Subject: Request for Additional Information #1 Regarding, FutureGen Applications for UIC Permit nos. IL-137-6A-0001, -0002, -0003 & -0004, dated October 31, 2013

| 10-31-2013: Letter from Rebecca Harvey (EPA) to Kenneth K. Humphreys (Alliance), "Request for Additional Information Regarding four FutureGen 2.0 Wells, United States Environmental Protection Agency Underground Injection Control (UIC) Permit Applications for Four Geologic Sequestration Wells; United States Environmental Protection Agency UIC Permit Nos. IL-137-6A-0001, -0002, -0003, & -0004" | | | | | | | |
| RAI # | Subject | Page | Doc. Sec. | Par. | EPA Comment / Question / Request | FutureGen Response | Footnote / Reference Citation |

RAI# 10-31-2013_001

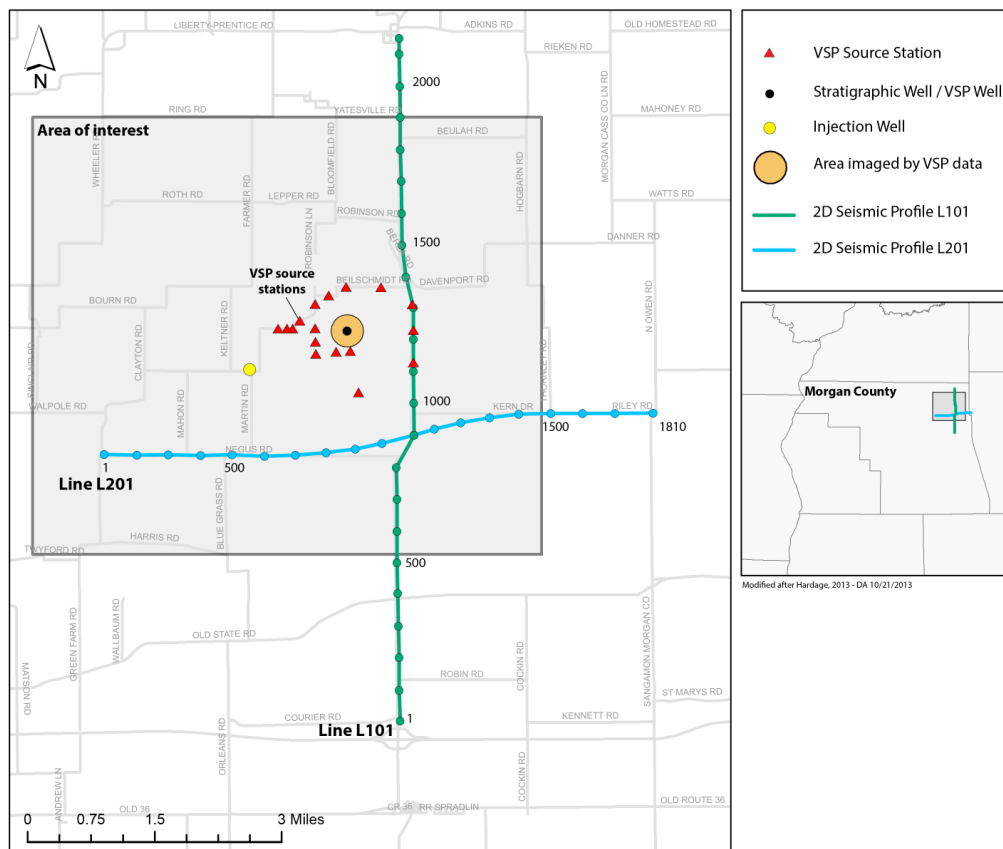
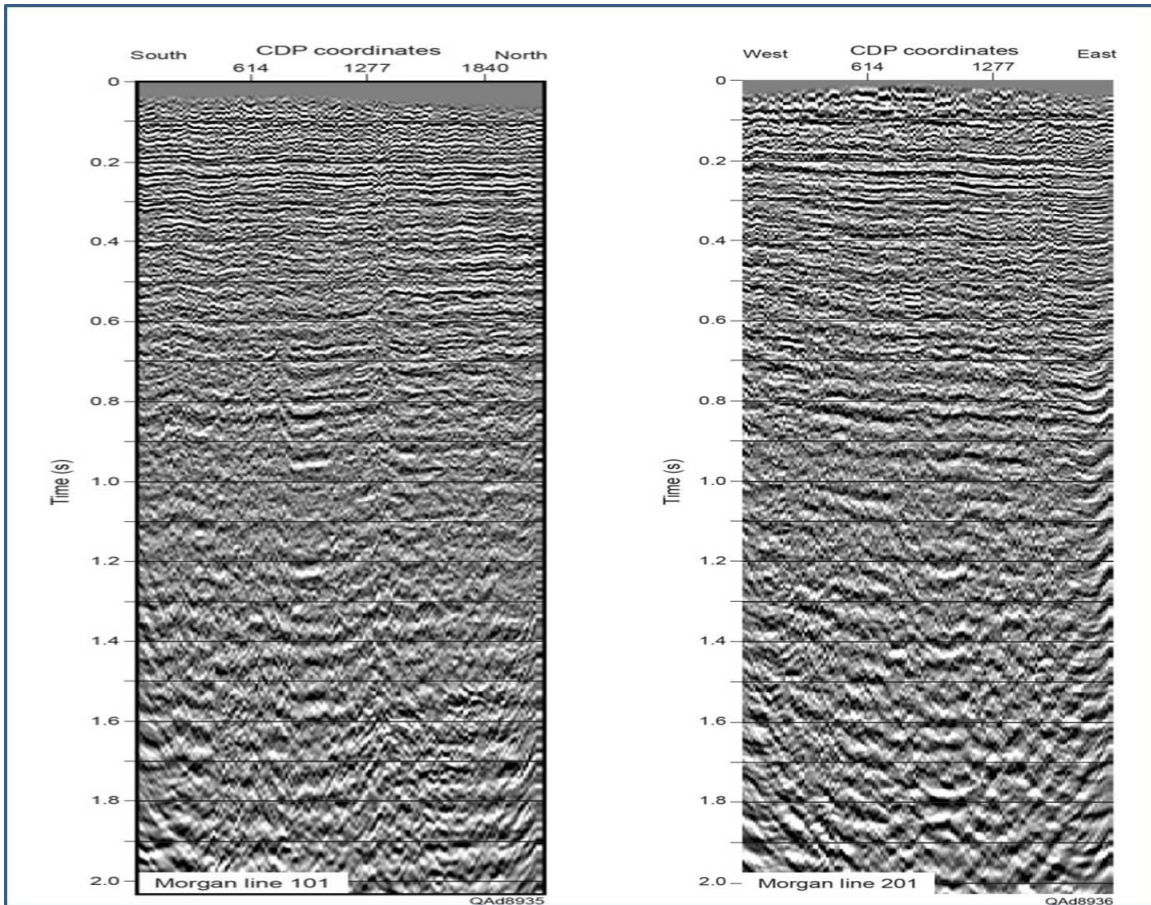
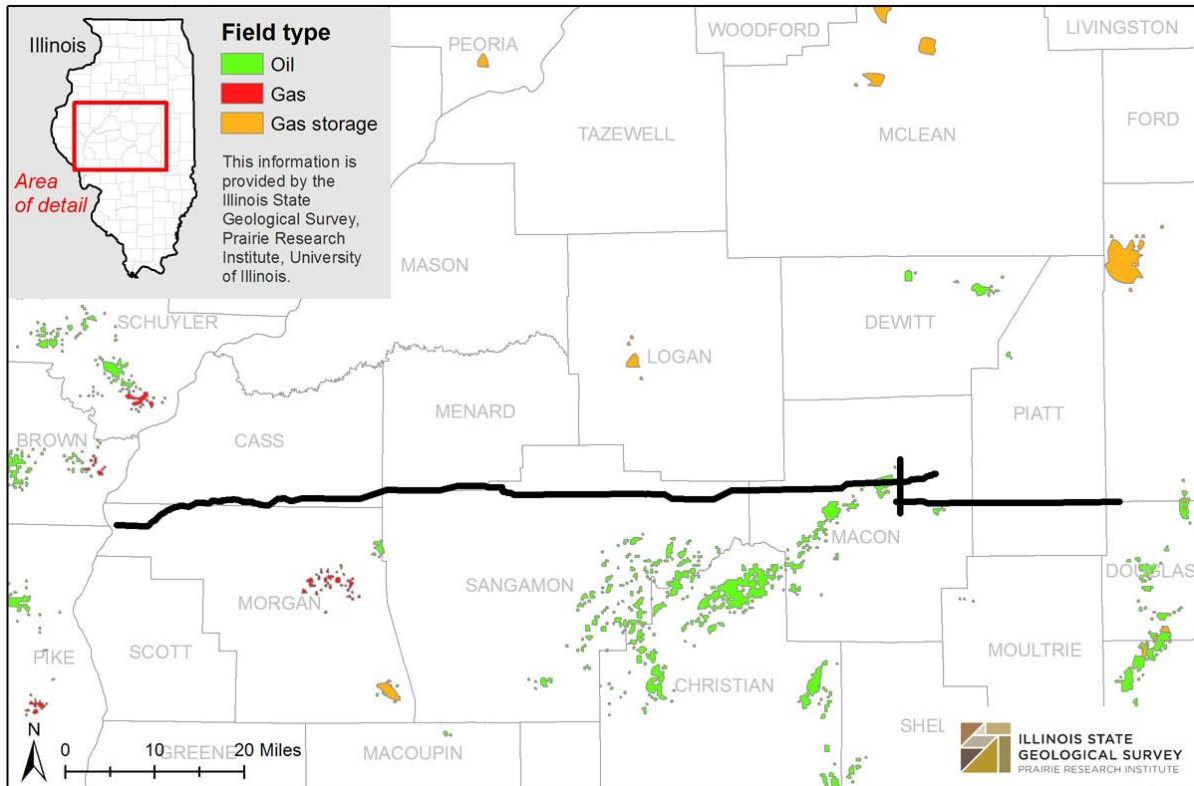
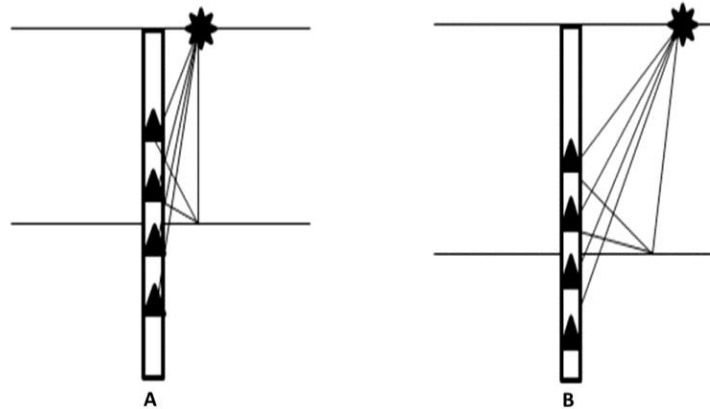
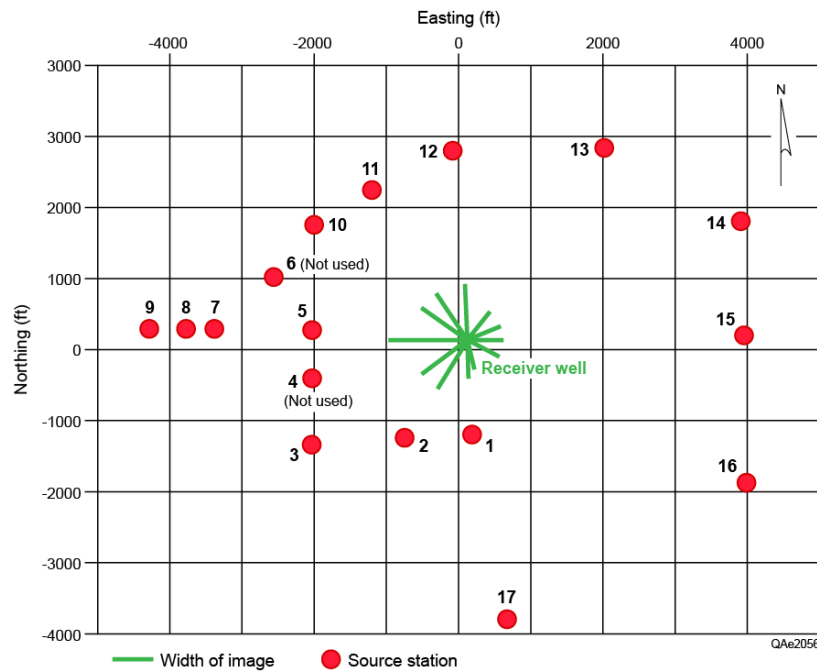
| 10-31-2013: Letter from Rebecca Harvey (EPA) to Kenneth K. Humphreys (Alliance), "Request for Additional Information Regarding four FutureGen 2.0 Wells, United States Environmental Protection Agency Underground Injection Control (UIC) Permit Applications for Four Geologic Sequestration Wells; United States Environmental Protection Agency UIC Permit Nos. IL-137-6A-0001, -0002, -0003, & -0004" | | | | | | | |
|--|---|------|-----------|------|---|--|--|
| 10-31-2013_001 | Seismic Reflection Survey & Vertical Seismic Profiling Data | 2.26 | 2.3.1.1 | 1 | <p>"The Illinois State Geological Survey (ISGS) recently acquired a new 120-mi long seismic reflection survey across central Illinois as part of a DOE-sponsored research project to characterize reservoir rocks for geologic storage of carbon dioxide. The continuous east-west line extends from Meredosia to southwestern Champaign County (Figure 2.14). This line, which is currently under re-processing, will supply additional information about the structure of the sedimentary layers which will be correlated to the observations made on both profiles L101 and L201."</p> <p>"Future efforts at Morgan County will also include the acquisition of vertical seismic profiling data in the stratigraphic well to better evaluate the cause of the vertical disruptions in seismic reflections observed on the two existing seismic profiles."</p> <p>EPA: Have these tests been completed? Please report the results.</p> | <p>A discussion regarding these specific requests is presented in Appendix A. A summary of the response is as follows:</p> <p>(1) The current processed Knox line was reviewed by Dr. John McBride, Brigham Young University, and formerly of the ISGS. Dr. McBride is an expert in Illinois seismic data. Dr. McBride's conclusion on the ISGS Knox line west of Ashland, Illinois, which is directly north of the proposed FutureGen storage site, is that there is no discernible faulting west of Ashland.¹ Dr. McBride also suggested that current plans to reprocess the ISGS Knox line would not likely result in a greatly improved image.² As a result, the technical team has cancelled plans to reprocess the ISGS Knox Line.</p> <p>Dr. McBride's interpretation of flat-lying, sedimentary layers with no major faults on the ISGS Knox Line west of Ashland correlates well with the technical team's interpretation of similar conditions on the Morgan County two-dimensional (2D) profiles L101 and L201.</p> <p>(2) A three-component vertical seismic profiling (VSP) data set was acquired from the FutureGen stratigraphic well in March 2013 and processed by Schlumberger Carbon Services. Dr. Bob Hardage of the University of Texas concluded³ that no faults are present in the 15 2D seismic lines formed by the 15 offset VSP locations. These lines represent a lateral interrogation extent of 800–1600 feet radially from the stratigraphic well. The VSP data also do not contain the disruptions observed in the two original 2D seismic profiles (L101 and L201) of the proposed storage site.</p> <p>A second opinion evaluation of the vertical disruptions in the 2D Lines L101 and L201 was undertaken by Dr. John McBride, who concluded¹ that although the presence of small throw faults cannot completely be ruled out, the seismic anomalies in the 2D lines are most likely related to incompletely removed surface static noise, or due to the application of suboptimal filters during processing.</p> | <p>¹Phone Conference of Battelle Technical Team with John McBride, September 16, 2013.</p> <p>²John McBride. Personal Communication with Charlotte Sullivan, October 29, 2013.</p> <p>³Bob Hardage, Personal Communication with Charlotte Sullivan, August 1, 2013.</p> |

The following discussion addresses the specific request for additional information regarding 2D-seismic profiles and vertical seismic profiling data (RAI# 10-31-2013_001).

Neither the 2D-seismic profiles (Line L101 and L201) acquired at the FutureGen 2.0 site nor the Knox profile exhibit any large scale structural features near the Morgan County site.

Discontinuities observed in the Morgan County 2D lines were not resolved by reprocessing the lines in 2012; two independent seismic specialists conclude that the remaining vertical discontinuities have a high probability of being artifacts due to acquisition and processing, specifically related to incomplete removal of surface seismic noise caused by offsets in acquisition lines (“crooked lines”) and streams, by the choice of filters used during processing, and other processing parameters.

A zero offset VSP and 15 offset VSP’s were acquired in March 2013 to better determine if faults or fracture zones are present at the site. The VSP images are good quality, and no vertical discontinuities were observed in any of the offsets. Interpretation by Dr. Bob Hardage⁷ of the data indicates there is no evidence of faulting within the VSP image space.

Figures 4.4, 4.5, 6.1, and 6.2

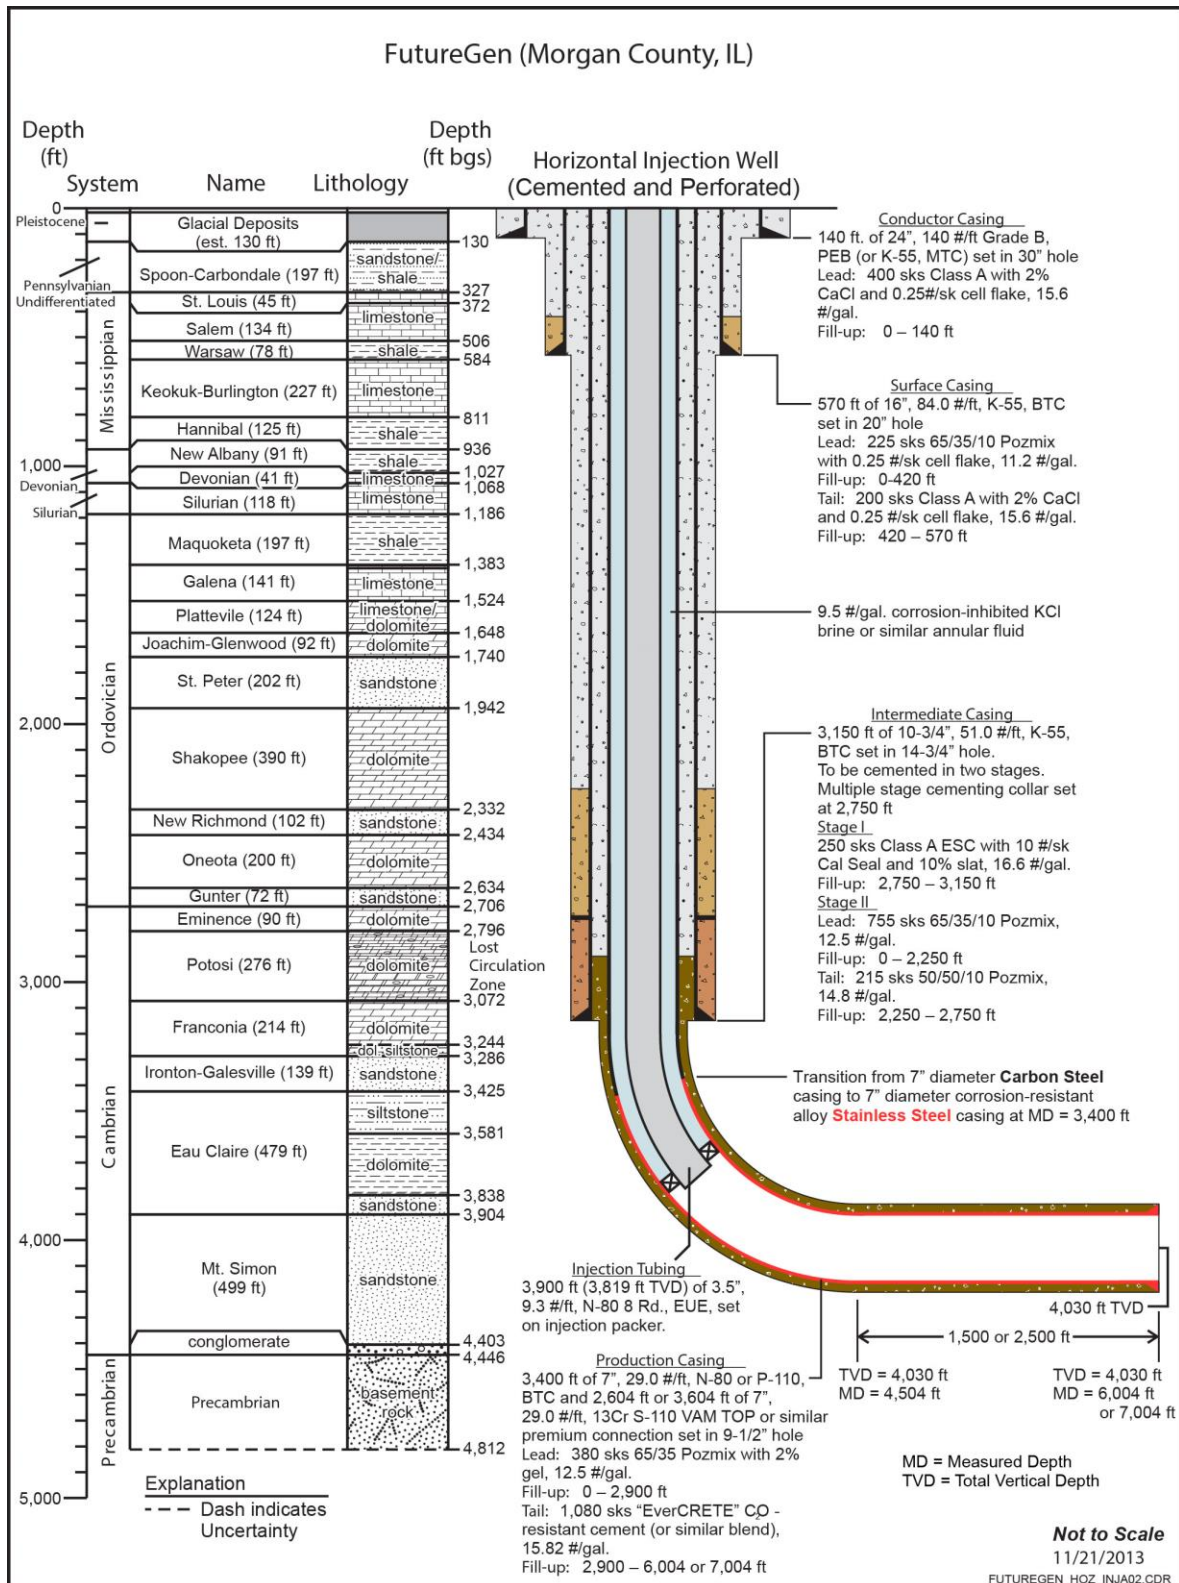
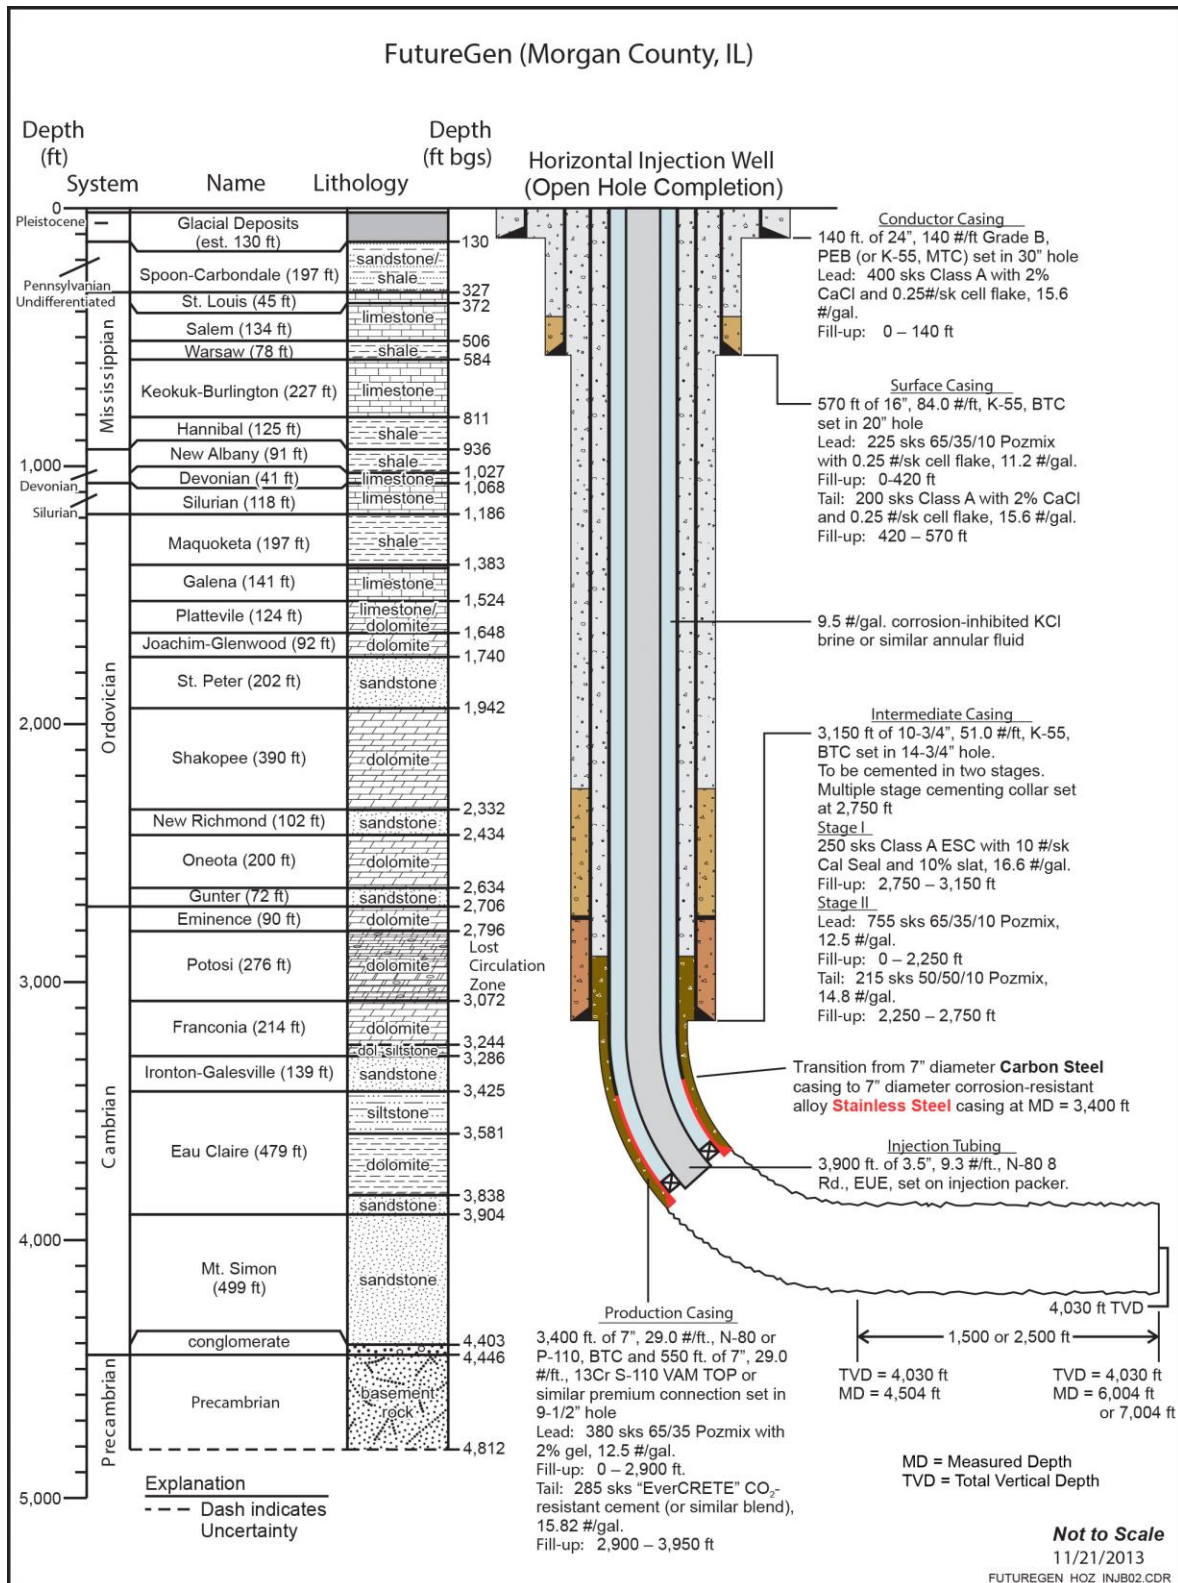
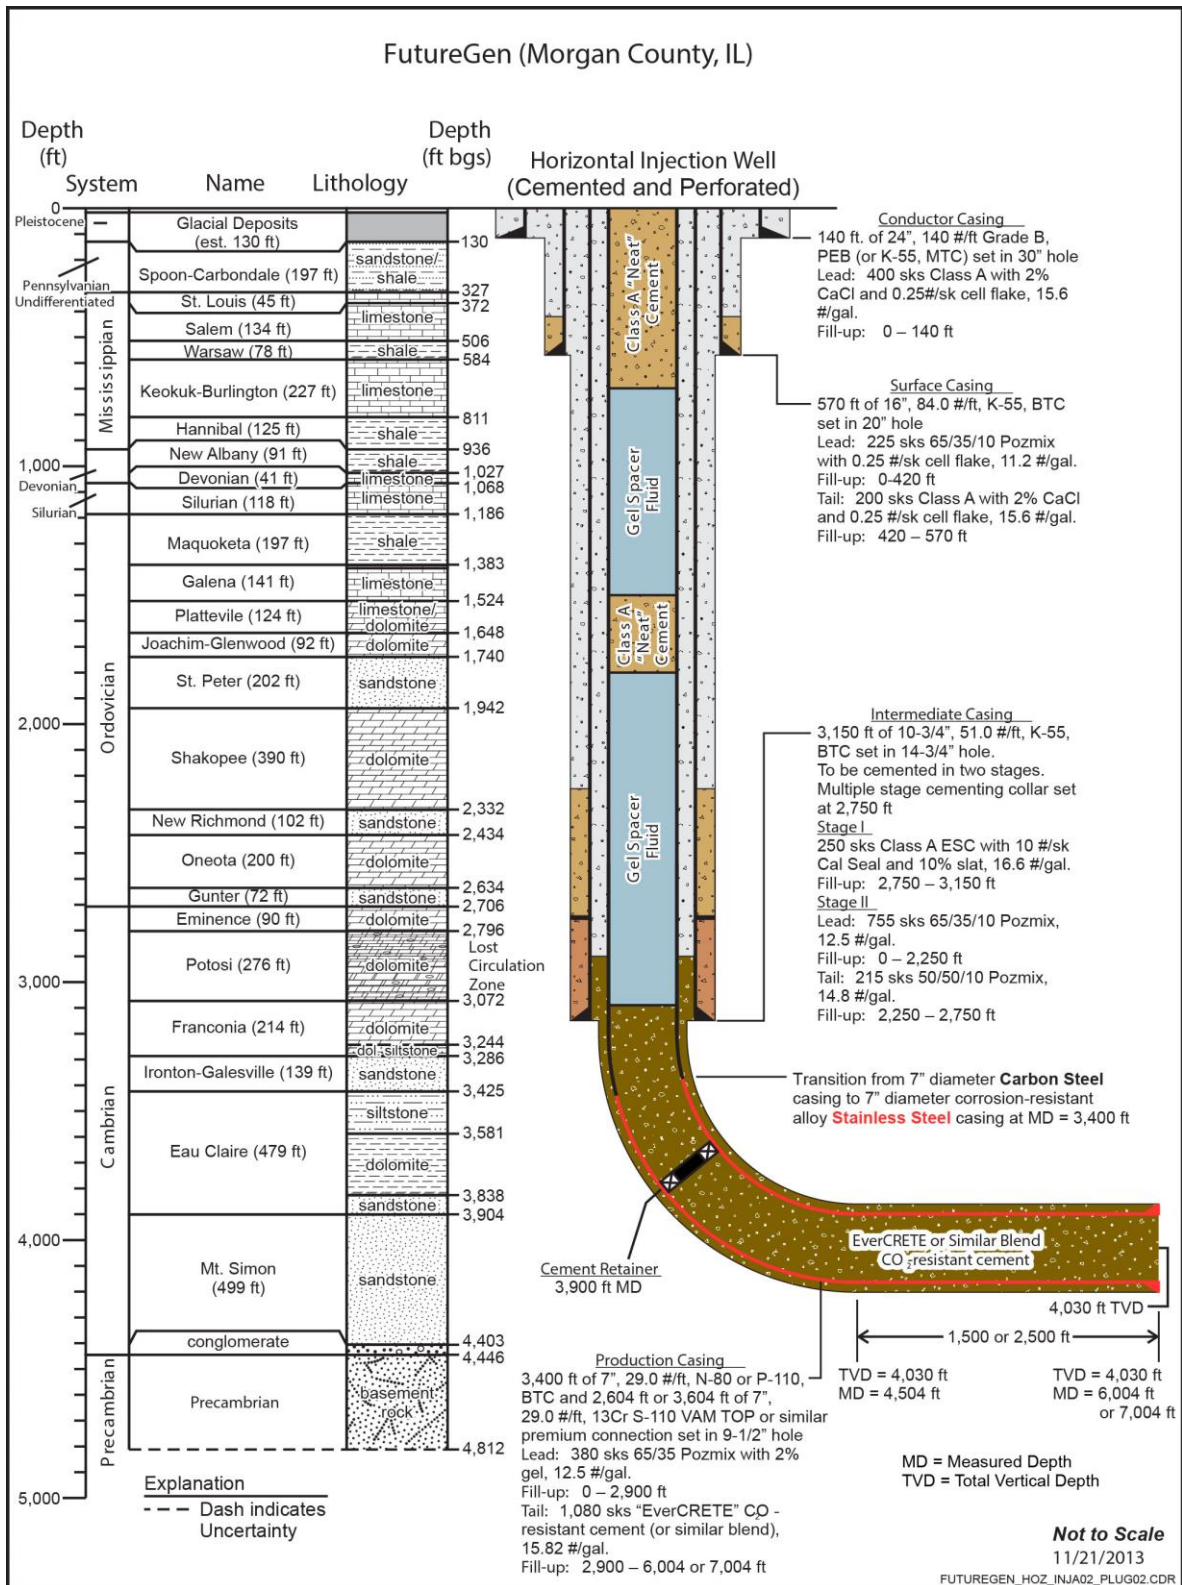
| 10-31-2013: Letter from Rebecca Harvey (EPA) to Kenneth K. Humphreys (Alliance), "Request for Additional Information Regarding four FutureGen 2.0 Wells, United States Environmental Protection Agency Underground Injection Control (UIC) Permit Applications for Four Geologic Sequestration Wells; United States Environmental Protection Agency UIC Permit Nos. IL-137-6A-0001, -0002, -0003, & -0004" | | | | | | | |
|--|---------------------------------|------|-----------|------|---|--|-------------------------------|
| 10-31-2013_009 | Casing & Retainer in Figure 6.2 | 6.5 | 6 | | <p>In Figure 6.2, the 7" casing is set at 3400 feet, however a cement retainer will be at 3900 feet, which is below the cased hole.</p> <p>EPA: Please correct.</p> | <p>The carbon-steel casing will be run to a depth of 3,400 ft and stainless steel casing will be run from 3,400 ft to 3,950 ft. For clarity, an updated version of Figure 6.2 is attached in Appendix D. For consistency, Figures 4.4, 4.5, and 6.1 have also been updated and are provided in Appendix D.</p> | |
